# MANATEE COUNTY FLORIDA

SUBJECT: **Invitation for Bid # 09-2568-OV**  
Buffalo Road Re-Alignment (North of Erie Road) and Waterline Relocation  
Project, Palmetto, FL  
**(Project No. 307.6062260)**

## ADDENDUM # 1

**Attachment 3**  
**Engineer's Response to Questions**  
**and Answers**  
**Road Realignment**  
**(8) Total Pages**

B BUFFALO ROAD

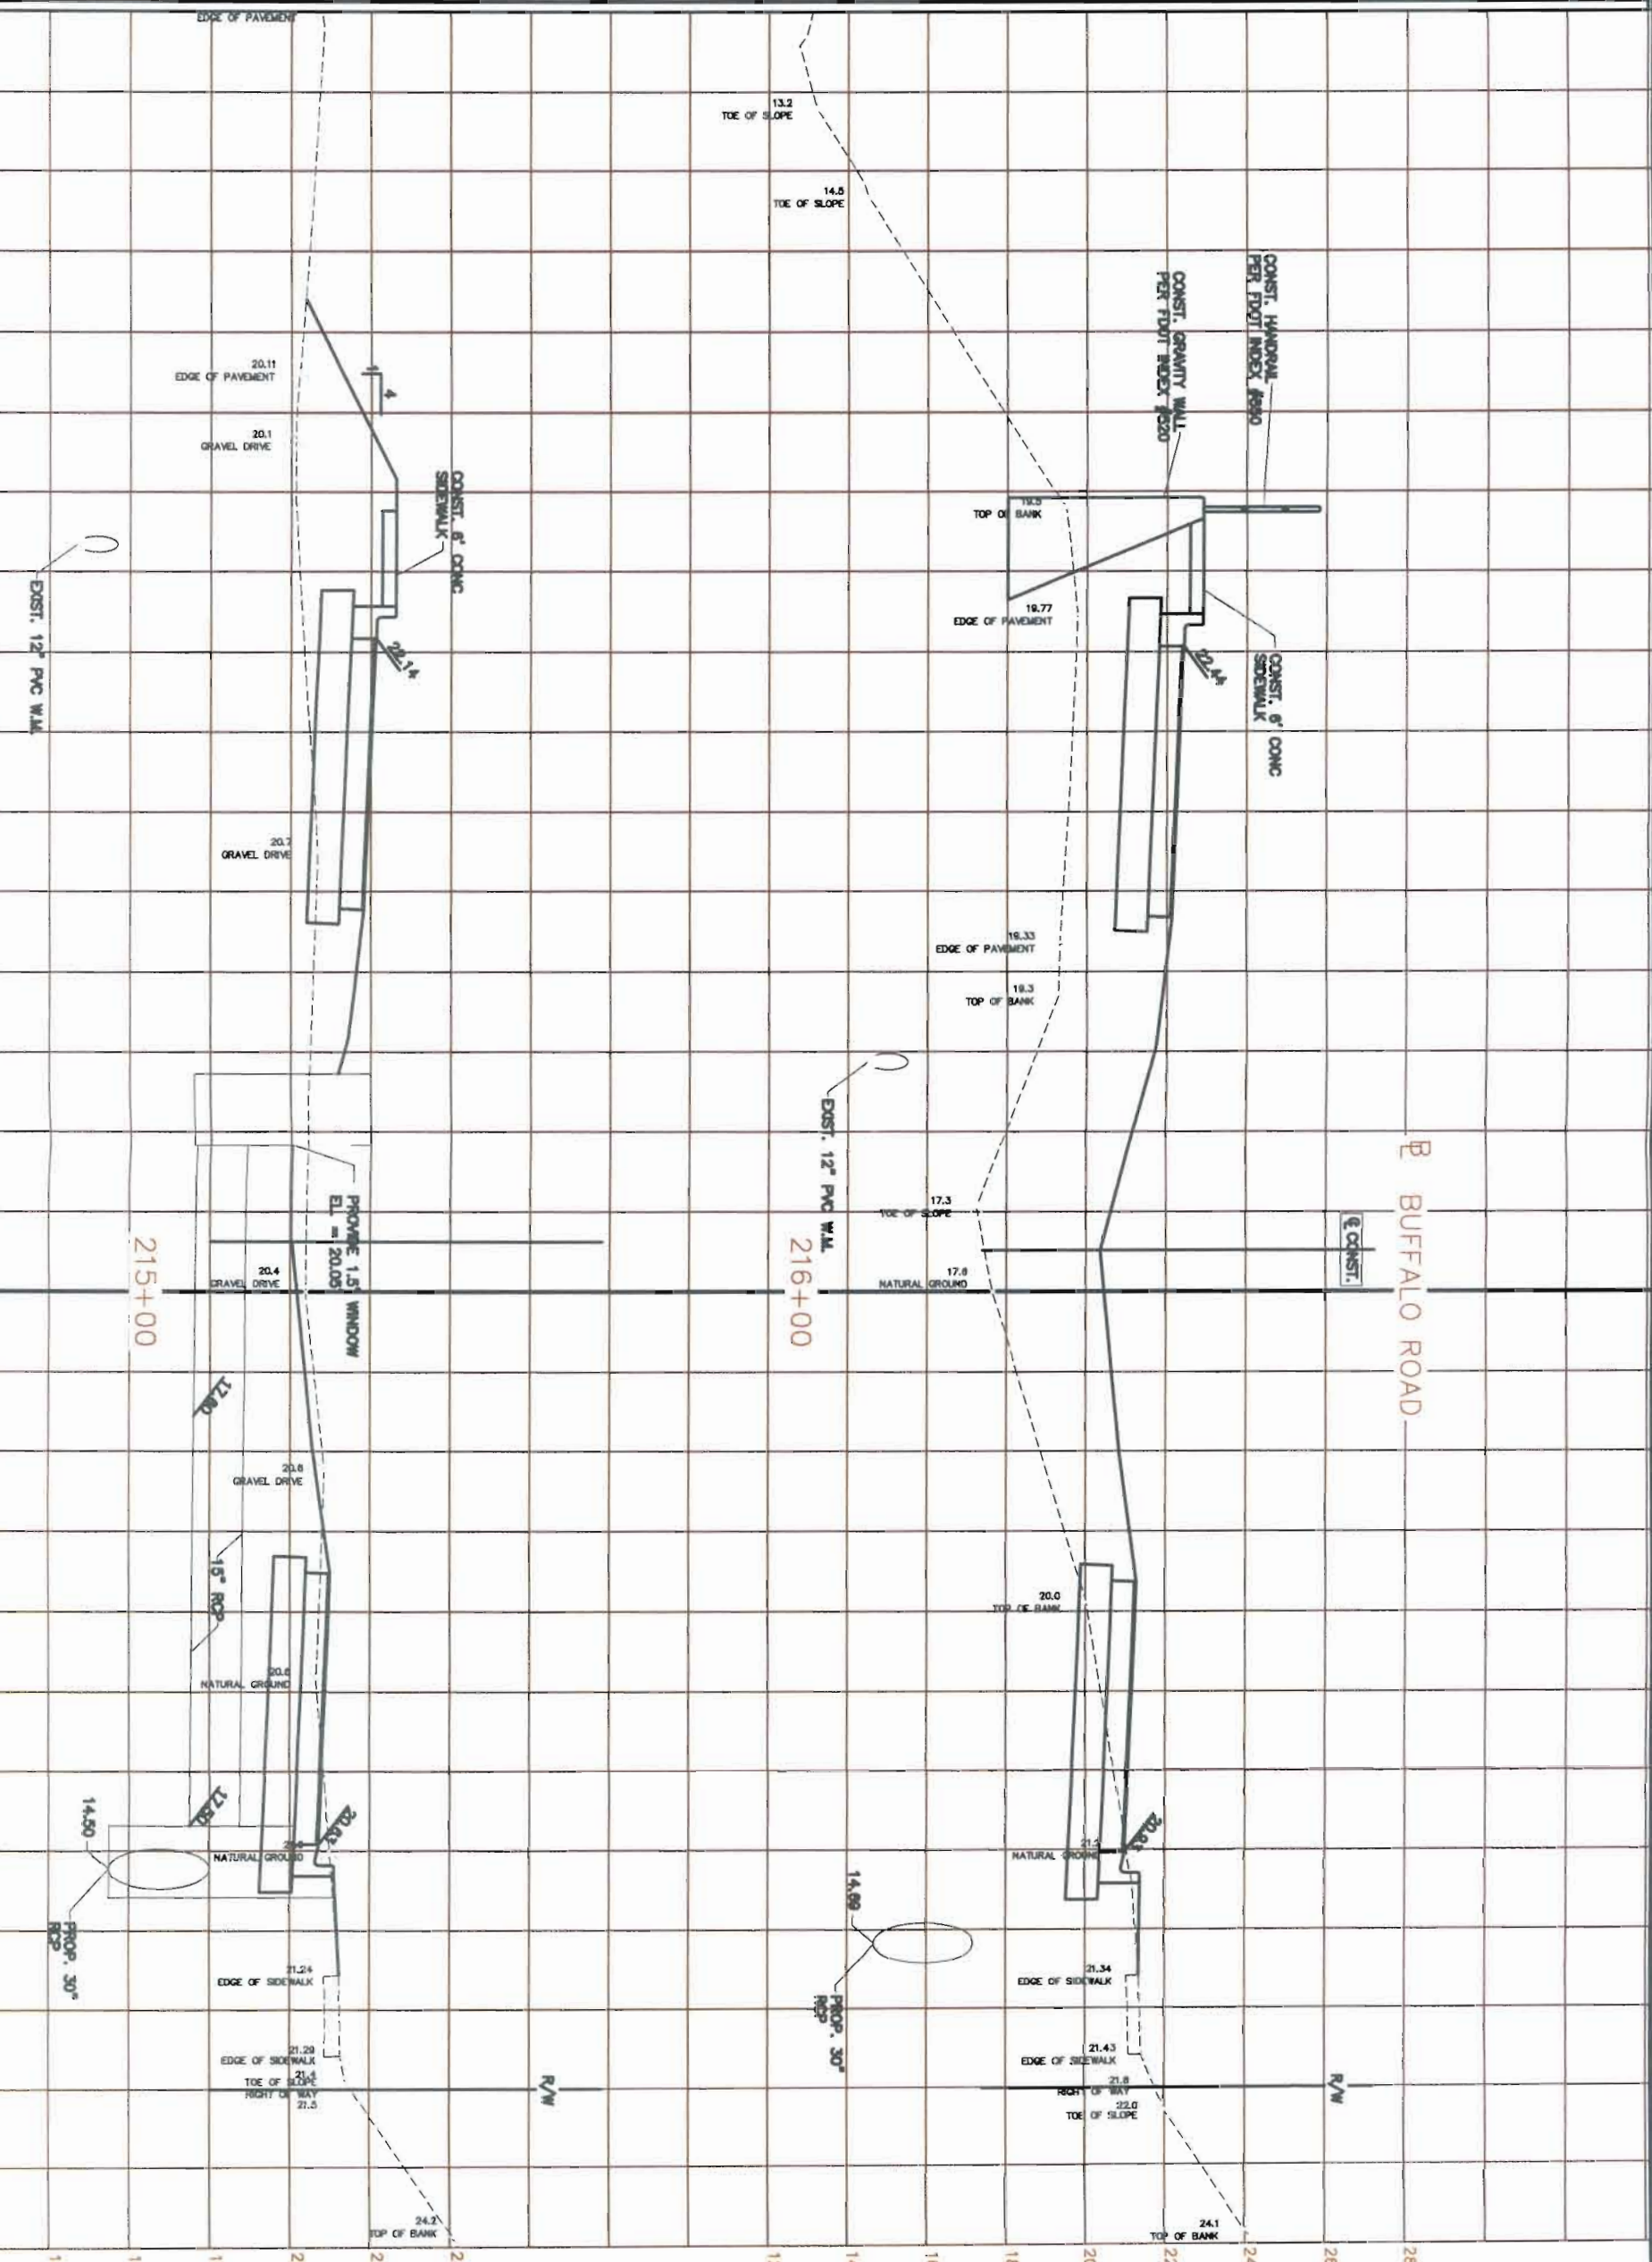
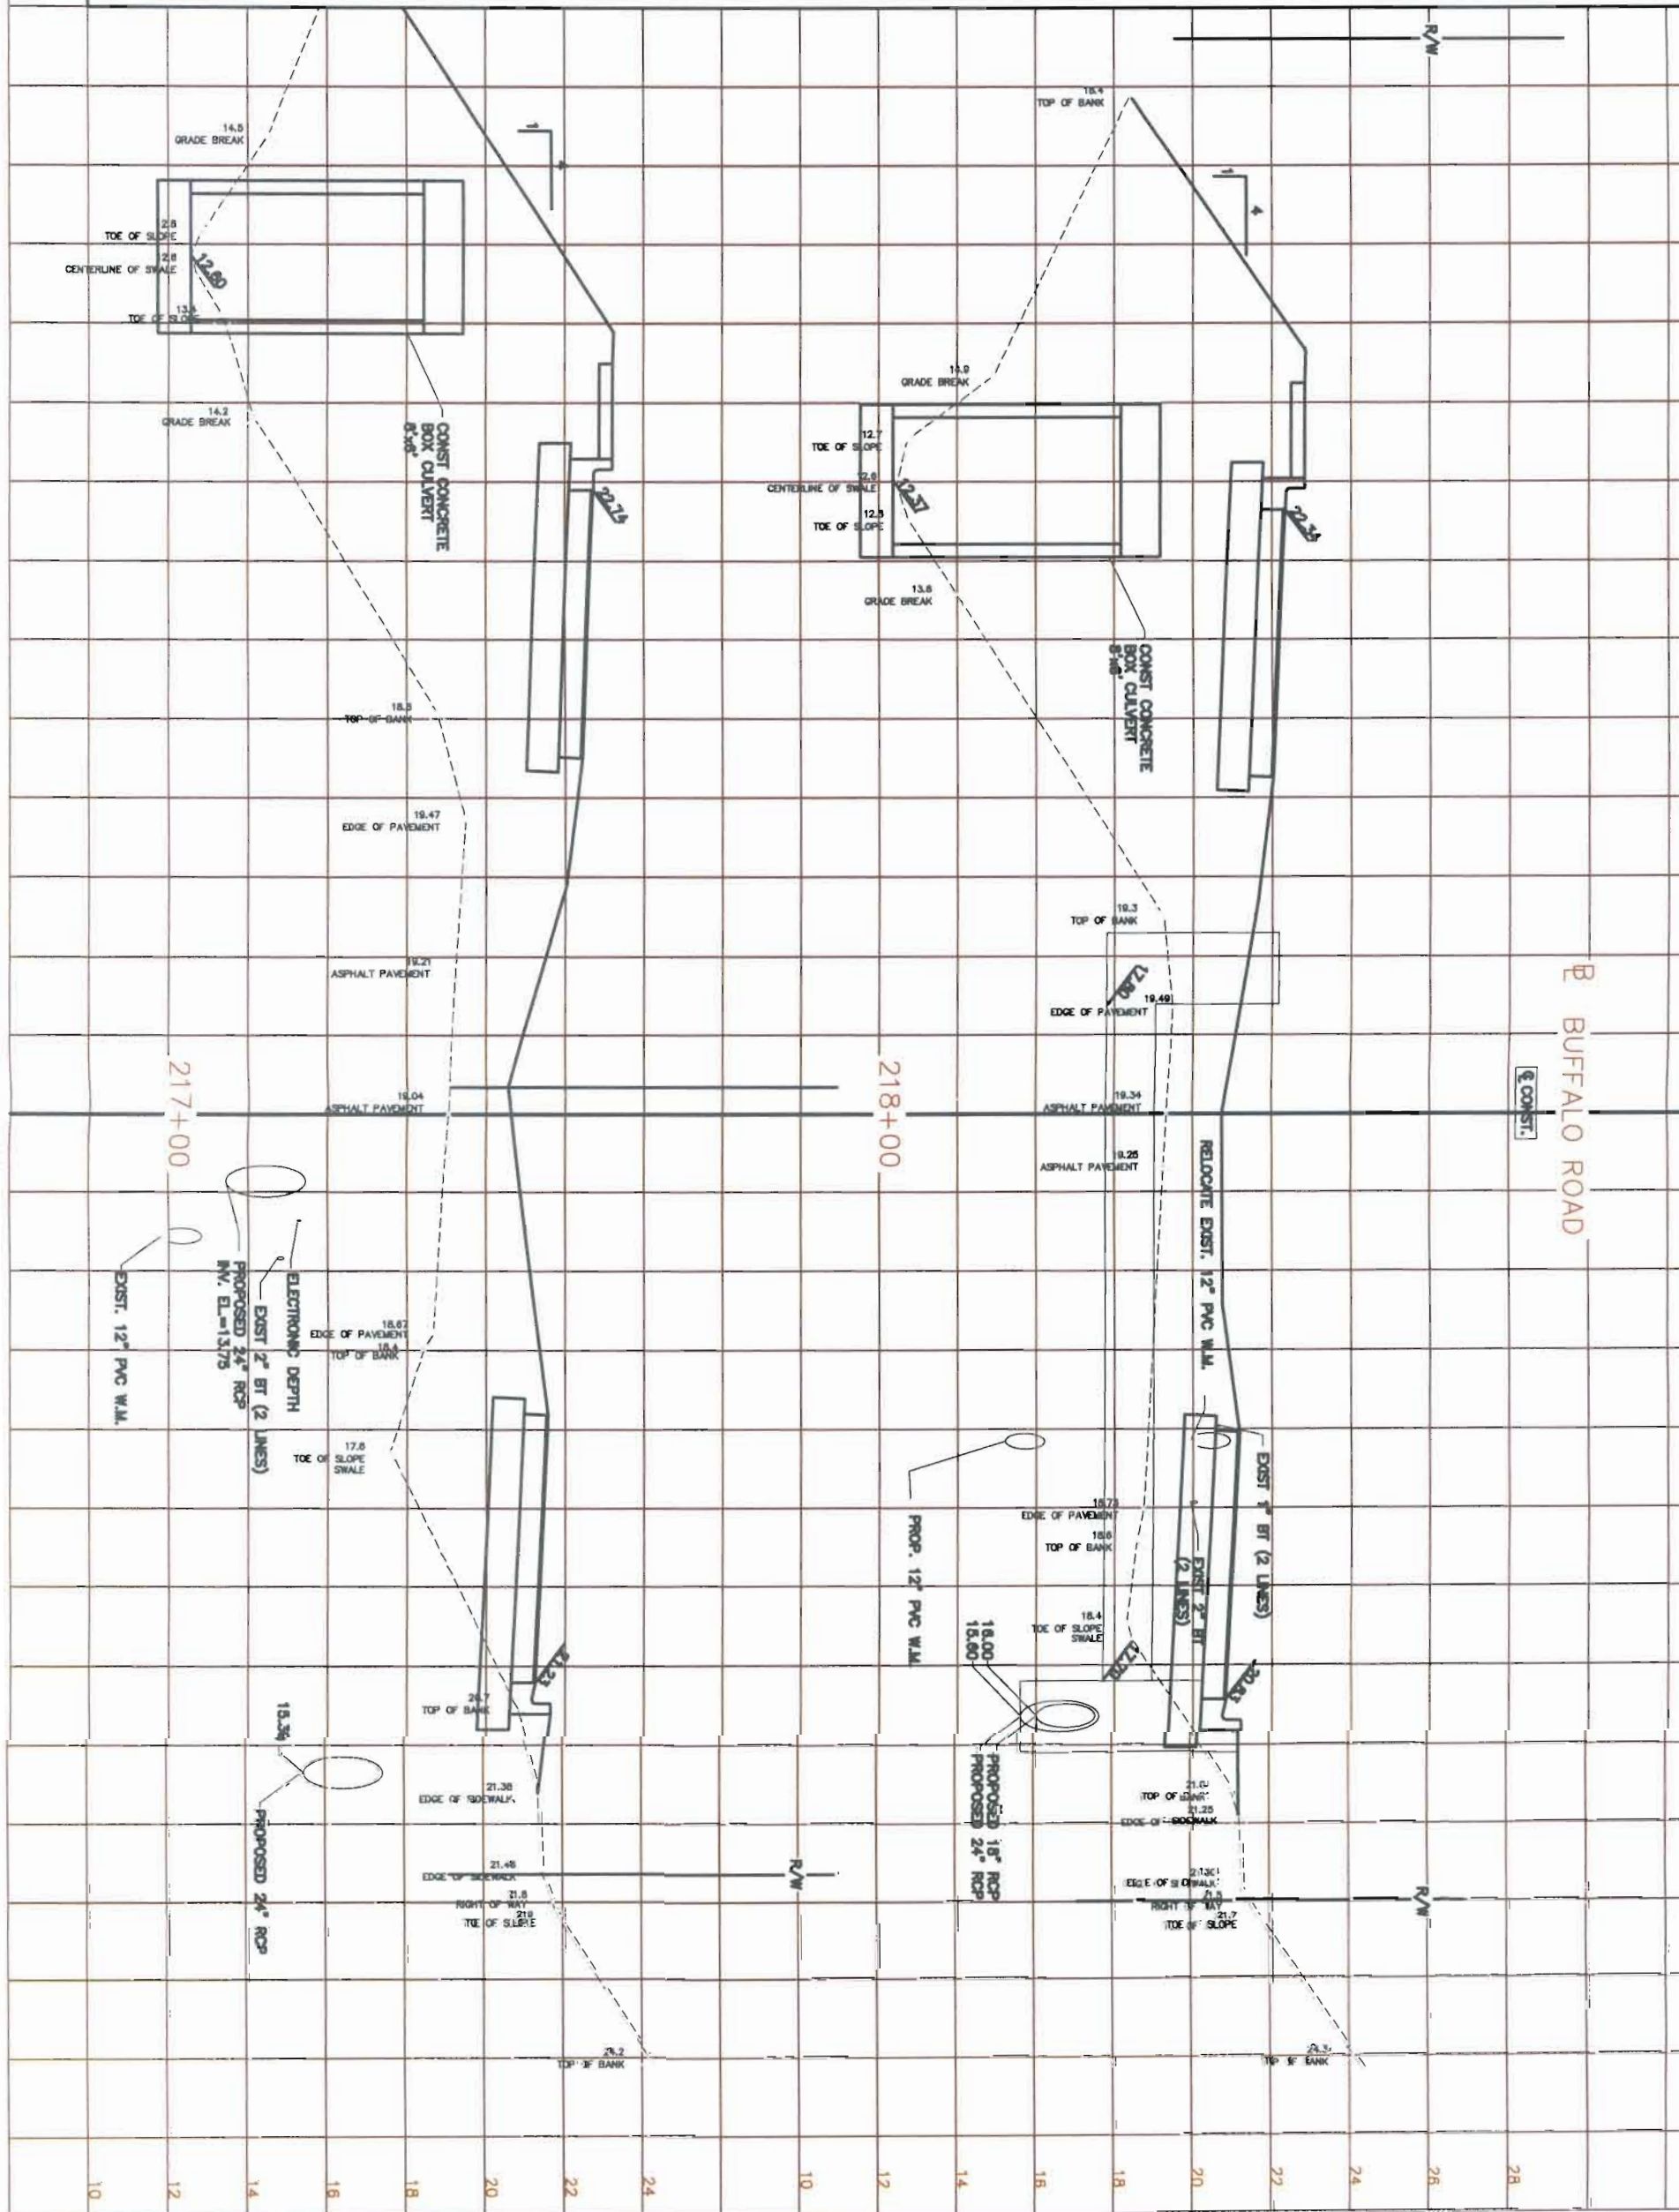
Q-4: The earthwork quantities appear to be incorrectly calculated.

Ans: The earthwork quantities have been reviewed using the end area method; Bid Forms have been updated to reflect this change. The earthwork has been divided into the following items:

Bid Items	FDOT Items		
7	0120- 1	Regular Excavation	8,433 cy
8	0120- 2	Borrow Material needed	2,424 cy
9	0120- 4	Obliteration (Old Buffalo Road)	6,150 cy
10	0120- 6	Embankment	10,857 cy
